4.6.1 Organization

As described in Section 4.1.2, the Radioactive Materials Program will reside within the Environmental Health Division of the Vermont Department of Health. The staff responsible for the Agreement State Program work in the Radiological Sciences Program which is shown in the organization chart for the Environmental Health Division below. The staff devoting the most time to the Radioactive Materials Program are the Radiological Sciences Chief, the Senior Radiological Health Specialist, and the Radiological and Toxicological Scientist. The Program will also have support from the Division Business Administrator, the Environmental Health Information Director, the Environmental Compliance & Enforcement Advisor and additional legal support from the Office of the Attorney General. For emergency preparedness, the Radiological & Toxicological Analyst and State Radiological & Toxicological Risk Assessor support prevention, response and recovery efforts.

Figure 7: Division of Environmental Health

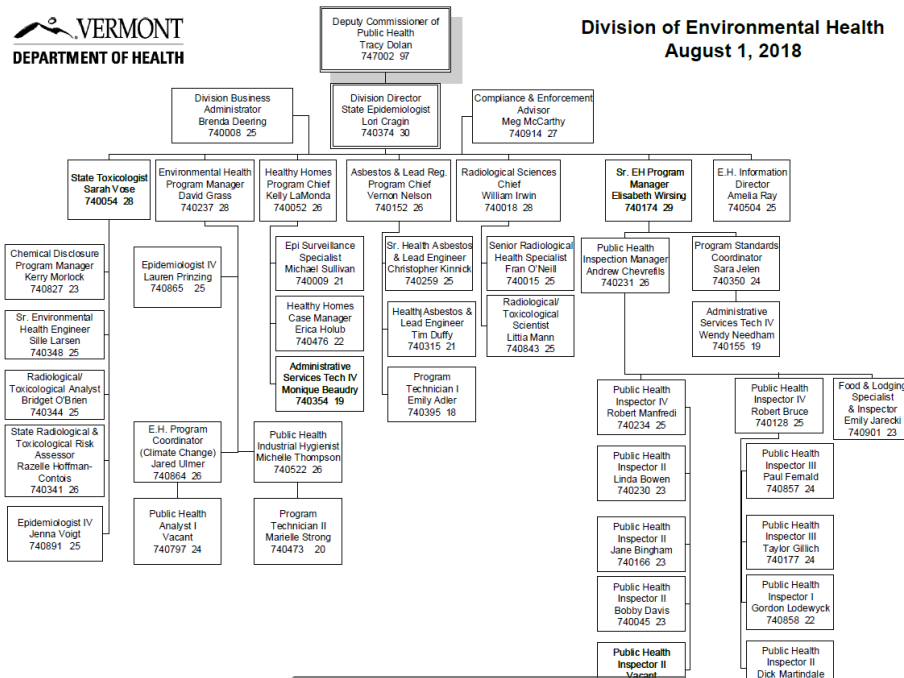
Commented [IW1]: NRC comment 33.
